**RE: Duke Energy Carolinas, LLC's and Duke Energy Progress, LLC's
Comments in Support of Inspections for Legacy Solar Generating
Facilities
Docket No. E-100, Sub 101**

2018/2019 Periodic Inspection Pilot Findings

Reliability & Power Quality Issues – Riser Pole System Neutral Elevation

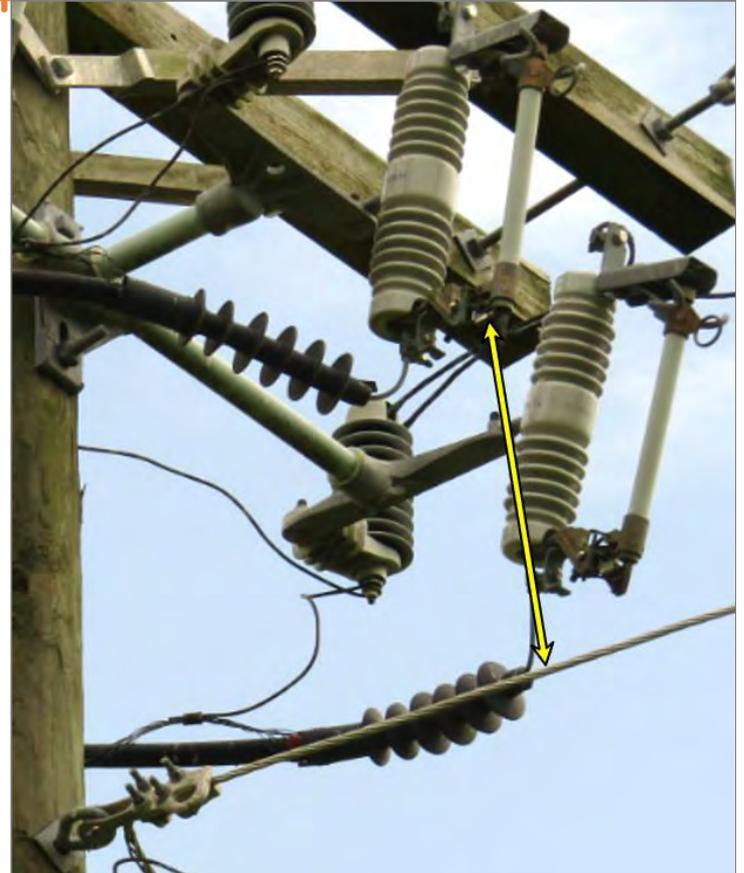
- System neutral installed too high
- Results in insufficient phase-to-ground clearance when cutout is opened
- Likely to cause a flashover when the middle phase cutout is open
- Requires terminators to be incorrectly installed horizontally

Incorrect Arrester Grounding

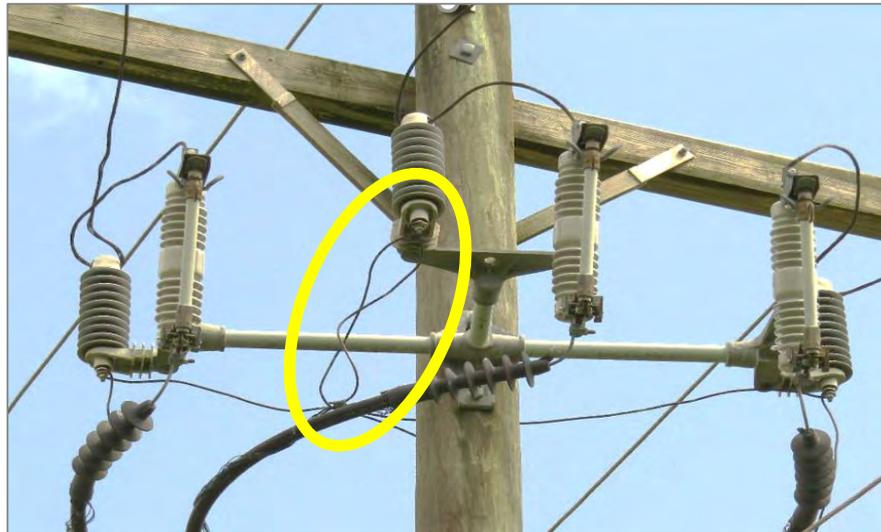
The lightning arrester ground leads are incorrectly connected to both the neutral bus and to the MV cable concentric neutrals. If an arrester fails it is likely to cause a phase-to-ground fault.

Undersized Equipment Jumpers

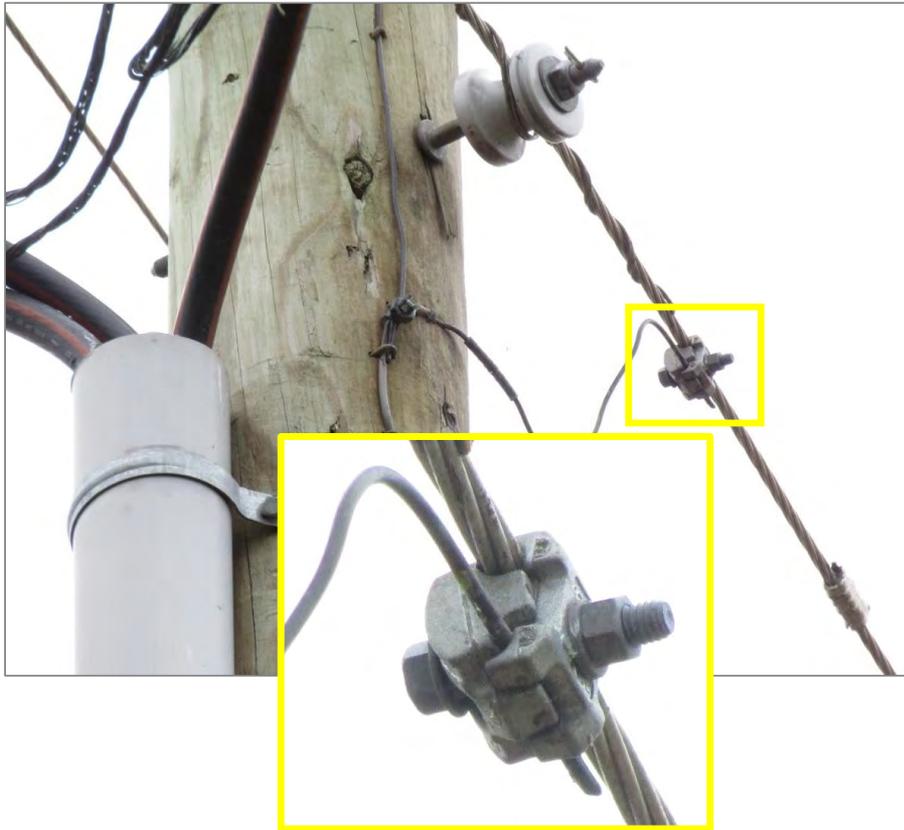
- 2 AWG stranded bare copper equipment jumpers are undersized for 232 Amp site rated current
- Minimum 1/0 AWG covered copper jumpers are required for rated current and wildlife protection

Ungrounded Junction Plates

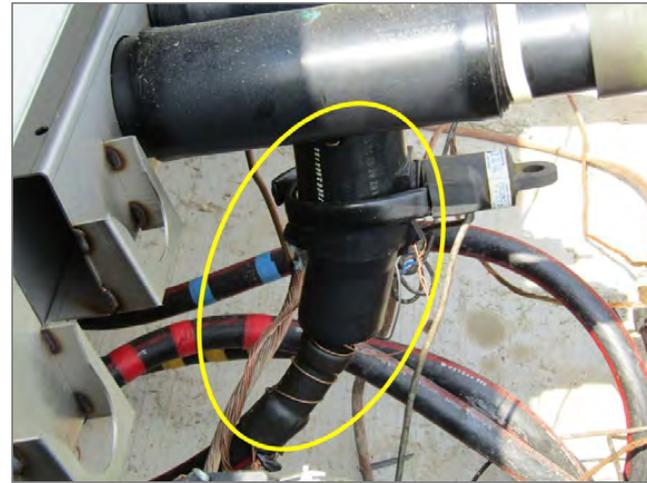
- Missing ground lugs and ungrounded junction plates in MV junction enclosure
- Results in a buildup of static charge on semi-conductive junction bodies, which presents a safety hazard to personnel
- May cause premature failure of junction due to corona discharge

Improper Grounding

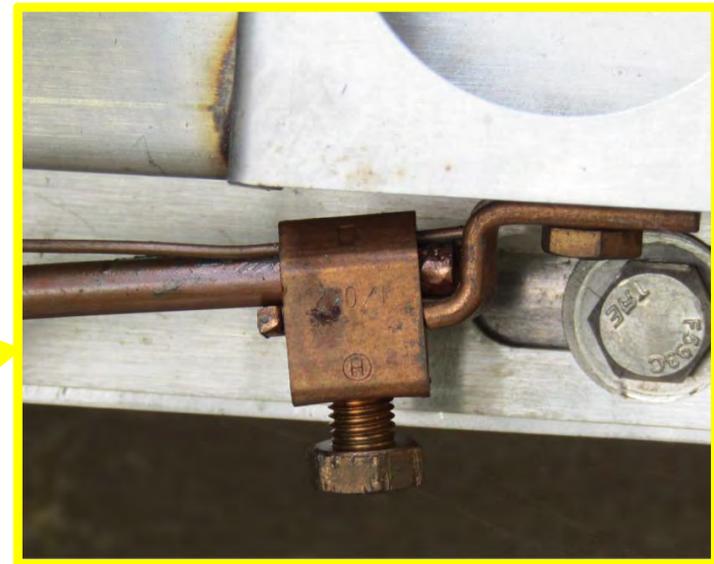
Two wires are installed in a lug that is only designed to accept one wire, so neither wire is ensured to maintain a good connection.

NEC 110.3(B) and 110.14(A)

Missing Elbow and Bushing Drains

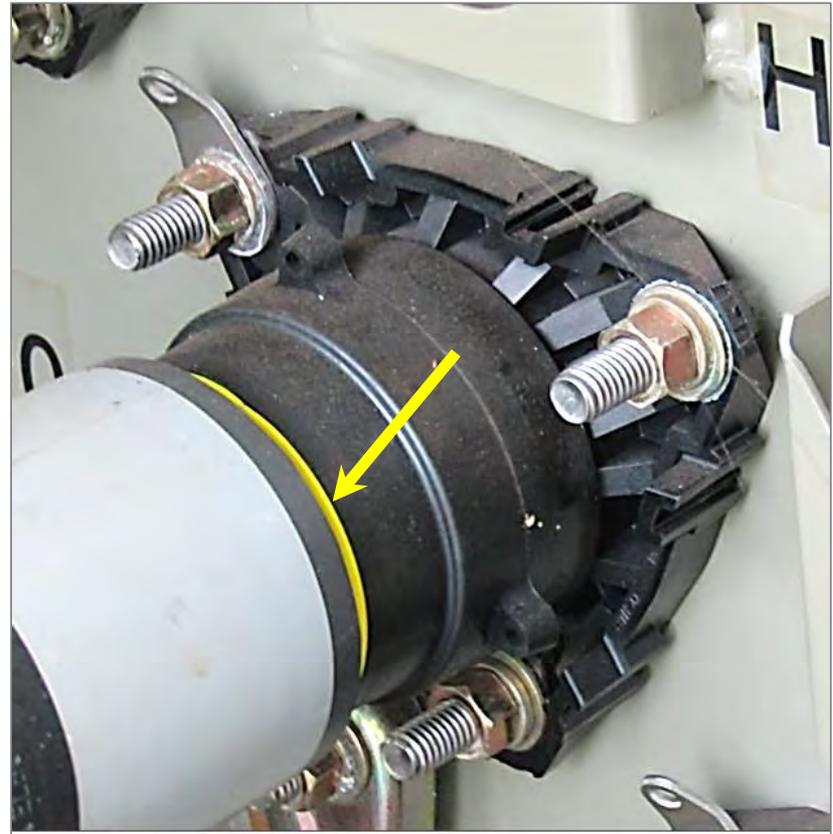
- Missing electrostatic drain ground wires on transformer bushing inserts, cable elbows and elbow arresters
- Results in a buildup of static charge on bushing accessories, which presents a safety hazard to personnel
- May cause premature failure of accessories due to corona discharge
- Electrostatic drain wires must be 14 AWG bare solid copper

Disconnected Electrostatic Drains

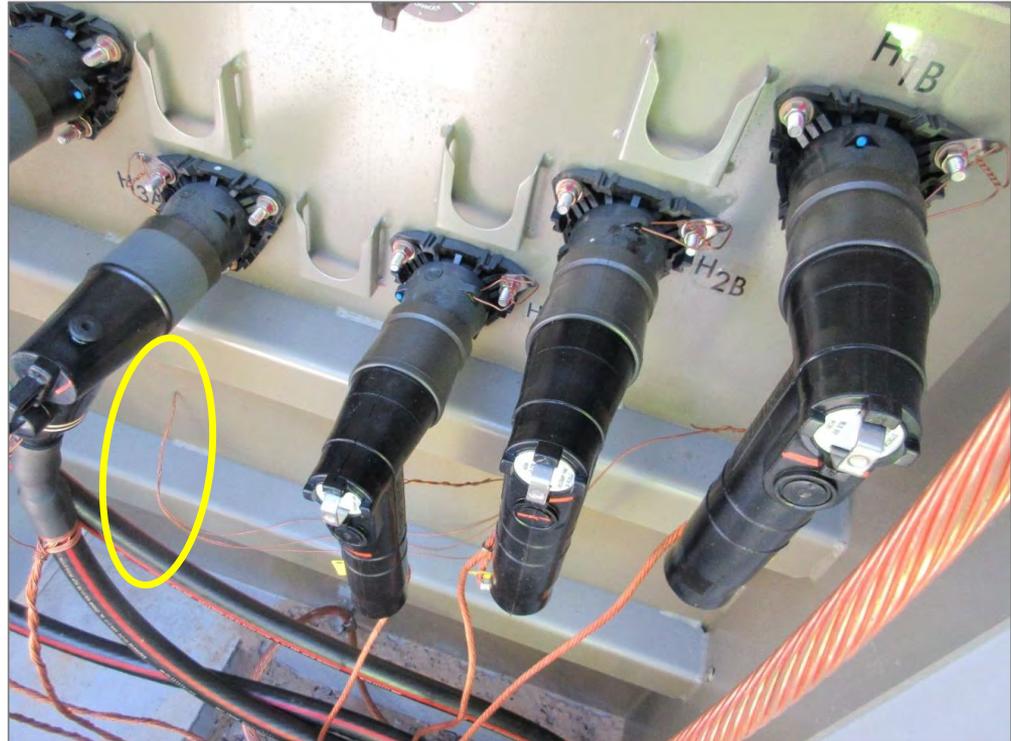
The electrostatic drain wires for the transformer lightning arresters are twisted together but not connected to ground, creating a shock hazard for O&M personnel.

Incorrect Tap Setting

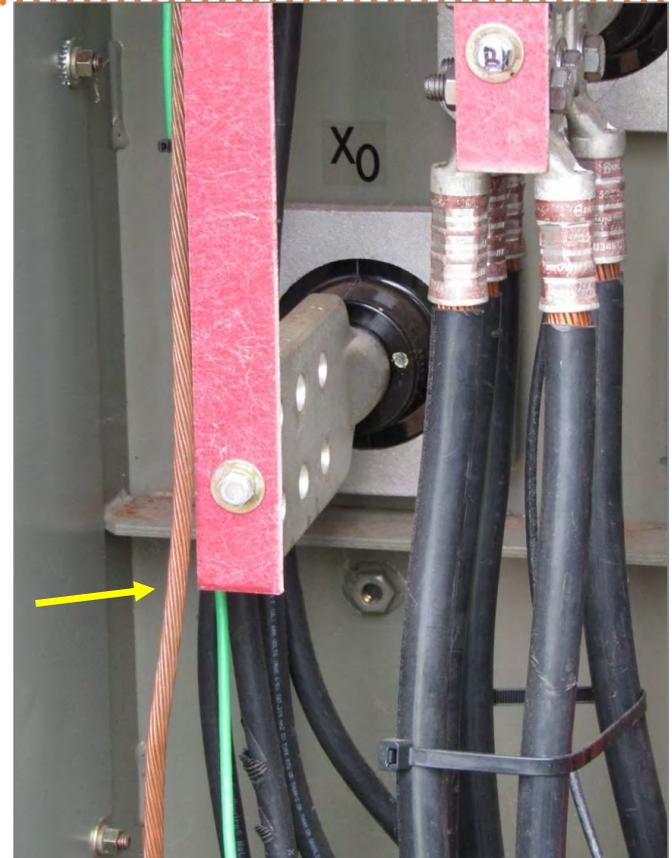
Transformer tap changer not set to nominal voltage tap C. Causes inverter settings to be out of compliance with the site Interconnection Agreement and IEEE 1547.

Incorrect Arrester Voltage Rating

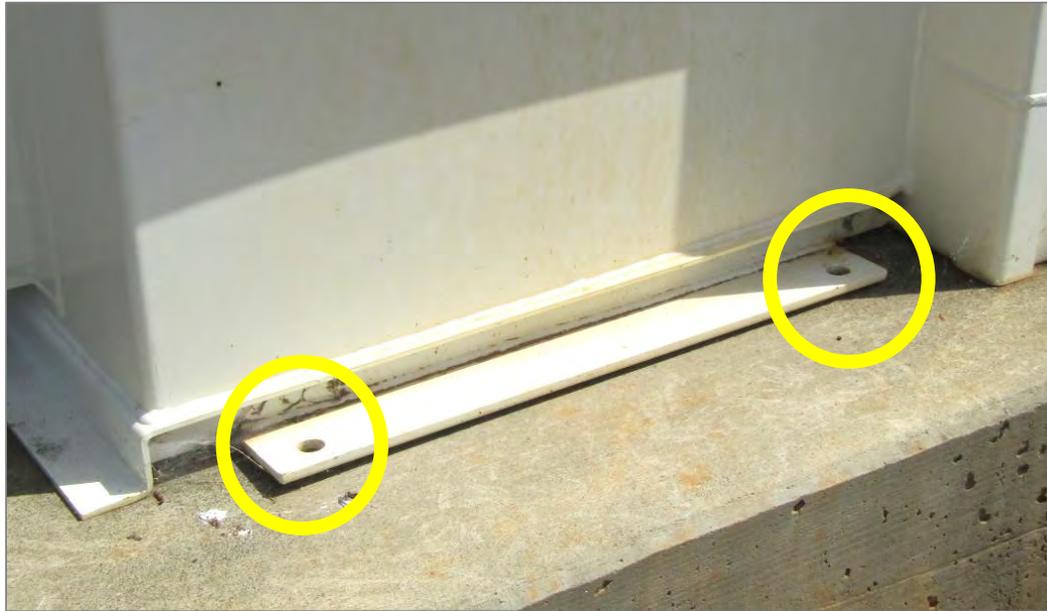
- 21 kV (17 kV MCOV) arresters installed on 23 kV transformer
- 18 kV (15.3 kV MCOV) arresters are required for adequate system protection

Incompatible Connector

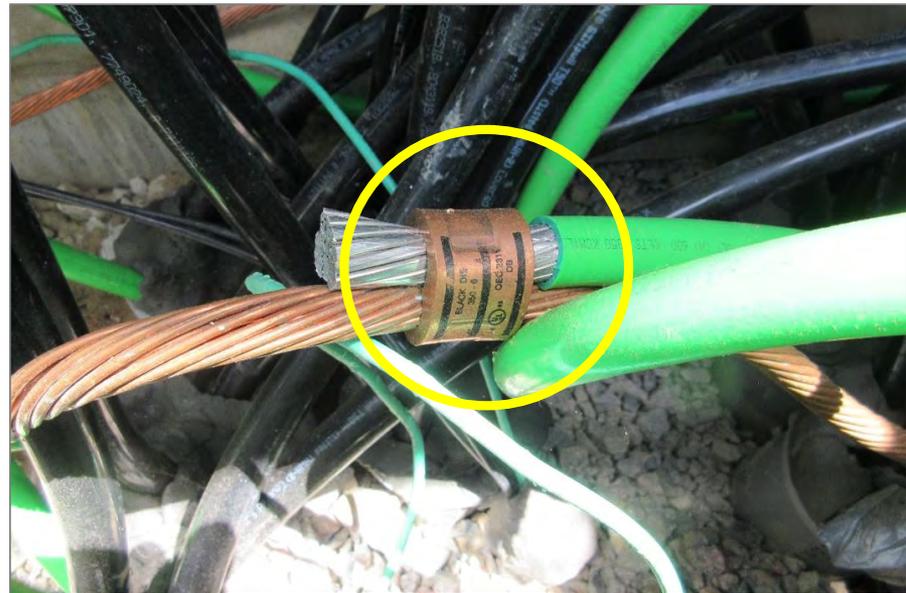
- Copper connector used on aluminum wire
- Aluminum wire and aluminum-to-copper wire connections require tin-plated aluminum connectors

Secondary Connection Lugs

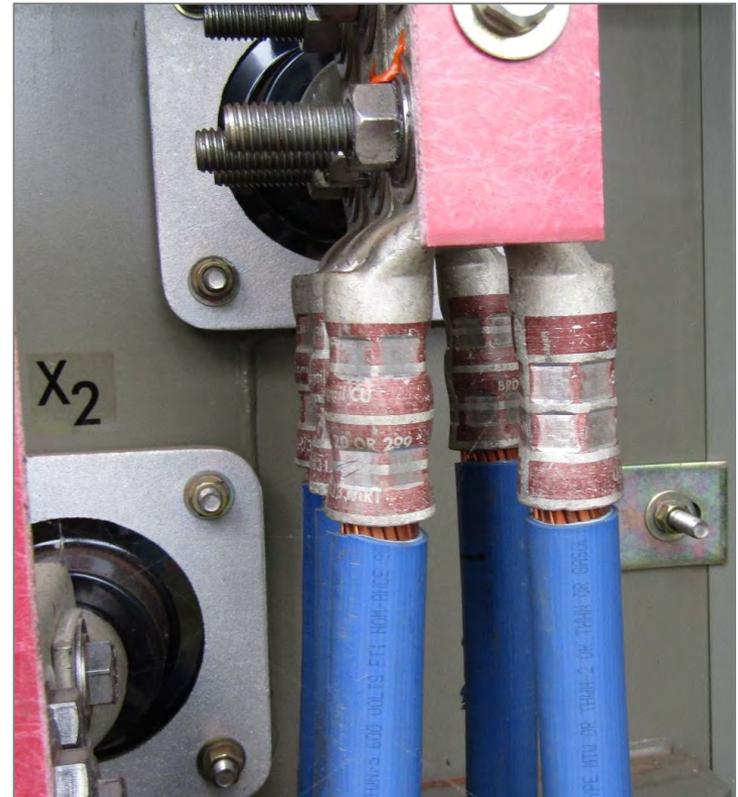
- Compression lugs have an insufficient number of crimps
- Lugs only have 2 crimps but 4 crimps are required
- 4 brown color bands indicate 4 crimps are required with the standard crimping die used for these connectors

Undersized MV Cable Sizing

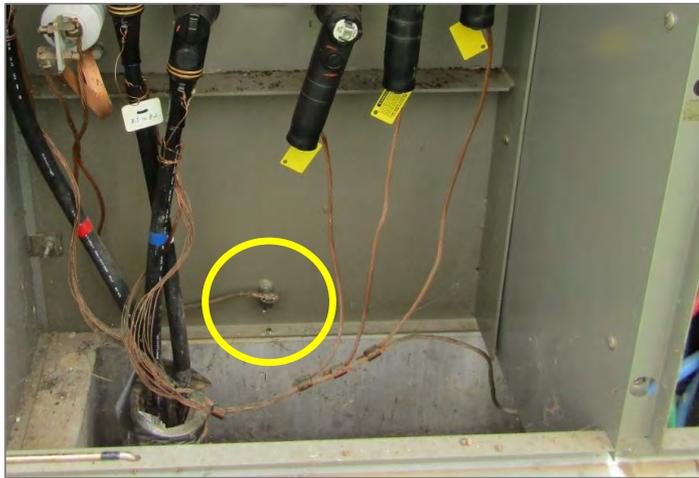
- 1/0 AWG AL MV cables are directly buried and have an ampacity of only 222 Amps
- Facility rated current is 232 Amps
- The cables are frequently overloaded for many hours per day and may fail prematurely

Disconnected Inverter Ground

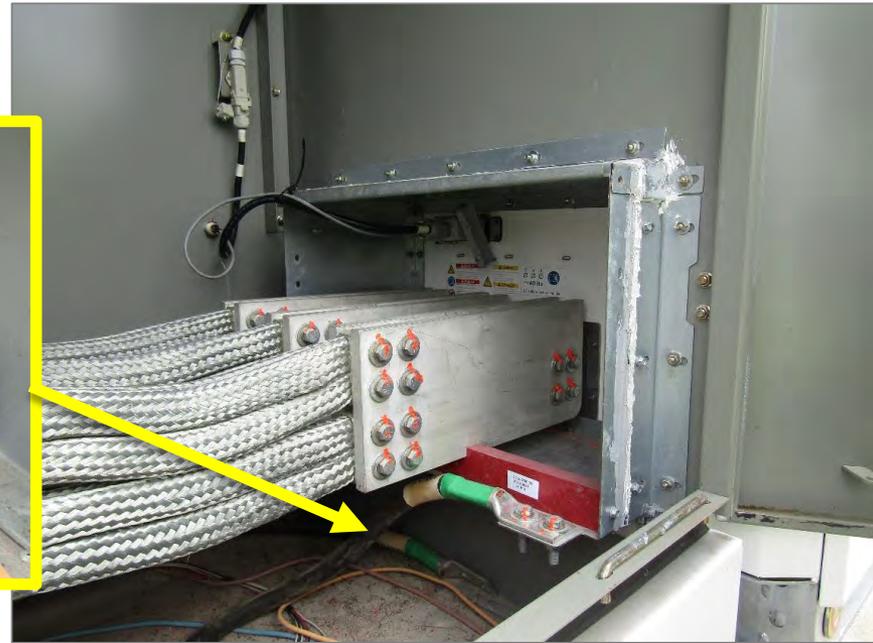
The 500 kcmil flexible copper ground cable between the inverter and transformer was not connected to the inverter ground bus bar in the throat connection cabinet.

Insufficient Secondary Conductor Voltage Rating

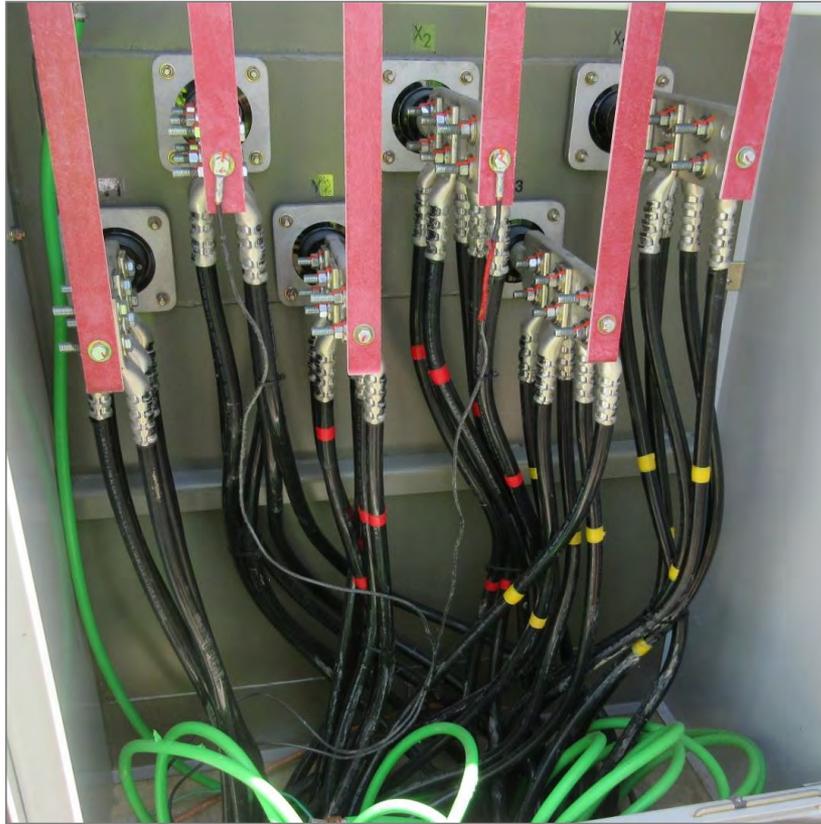
- 600-Volt conductors (THWN-2) have insufficient insulation
- Inverter RMS voltage to ground is 800 Volts and peak pulsed voltage to ground is 1450 Volts

Inverter Not Secured to Pad

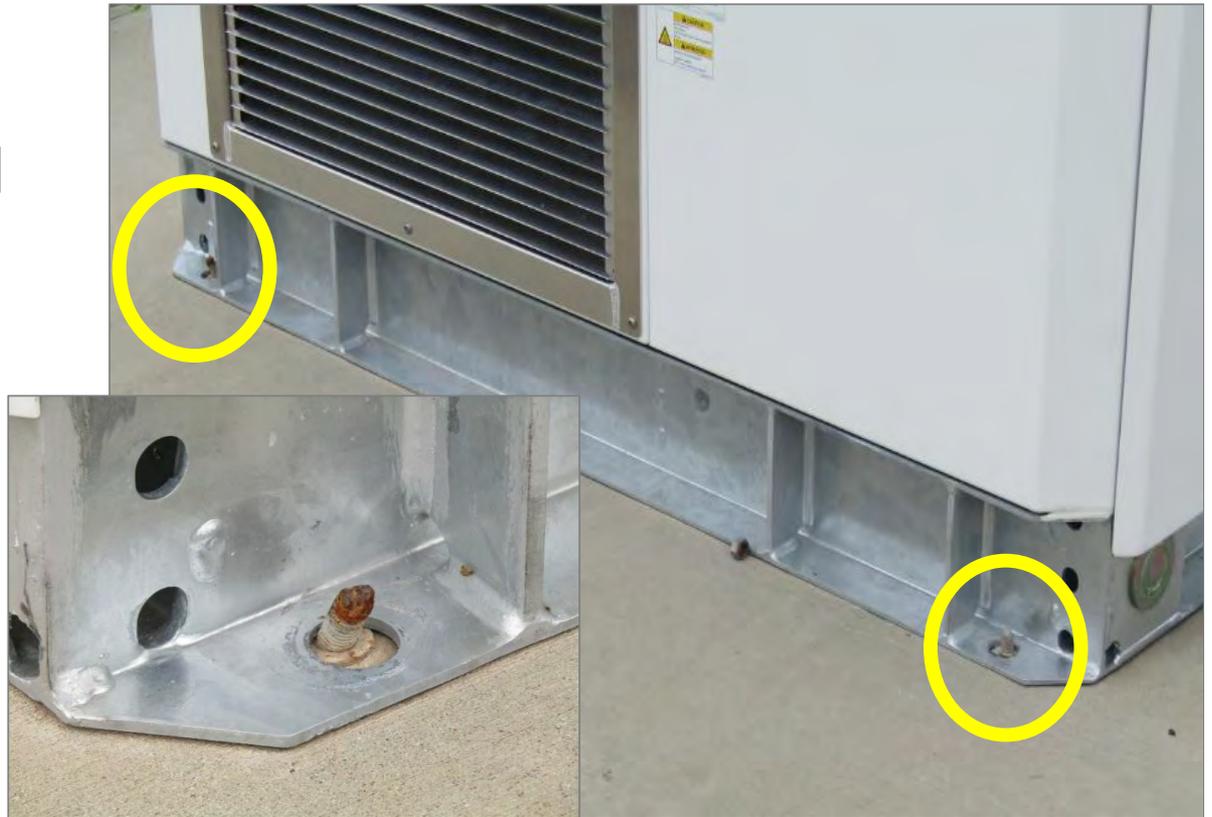
Replacement inverter not secured to pad after flooding destroyed two previous units.

NESC 180A1; NEC 110.3(B) and 110.13(A)

Example DEP Site

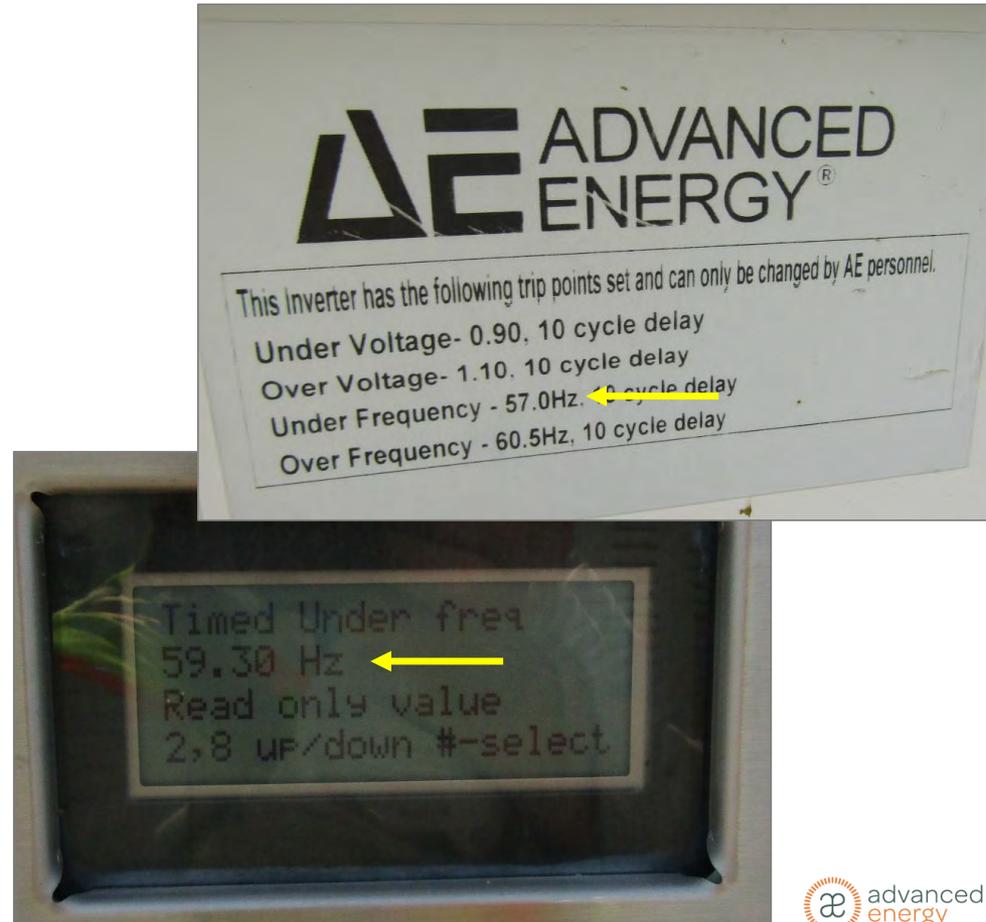
- Settings programmed into inverter do not agree with factory applied label
- Voltage and frequency settings set to default IEEE-1547 settings instead of Interconnection Agreement (IA) required settings

Power Factor

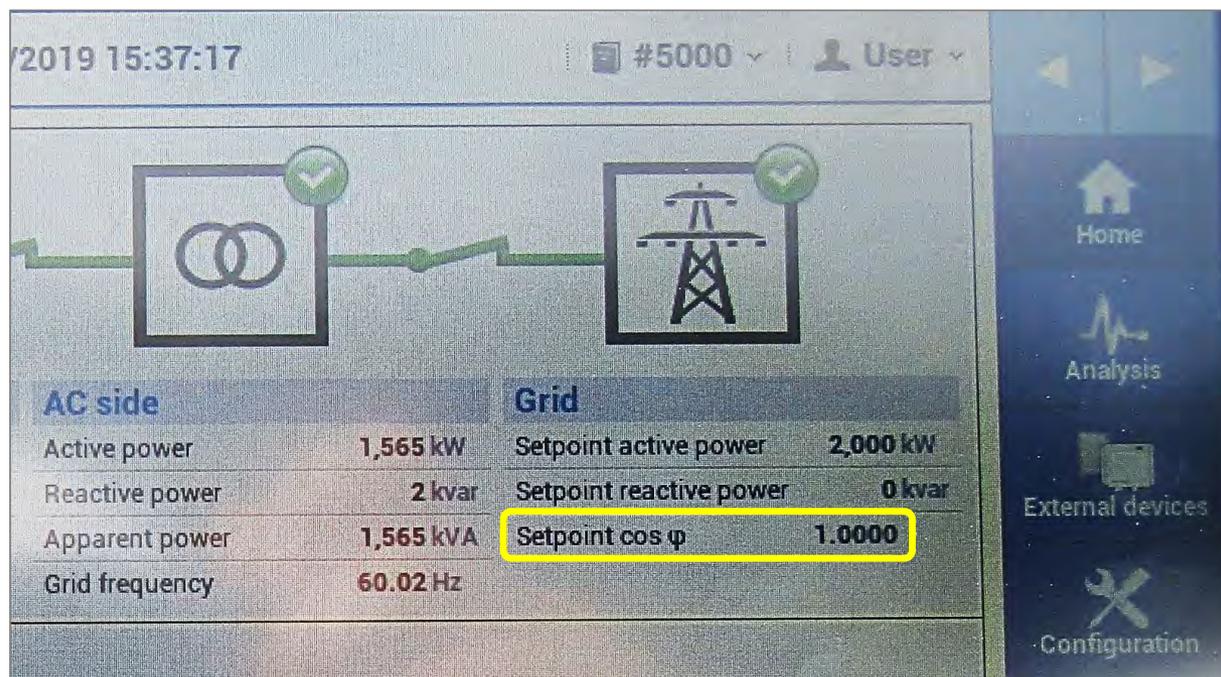
- IA requires 0.98 power factor
- One inverter set to 1.0 with other set to 0.98
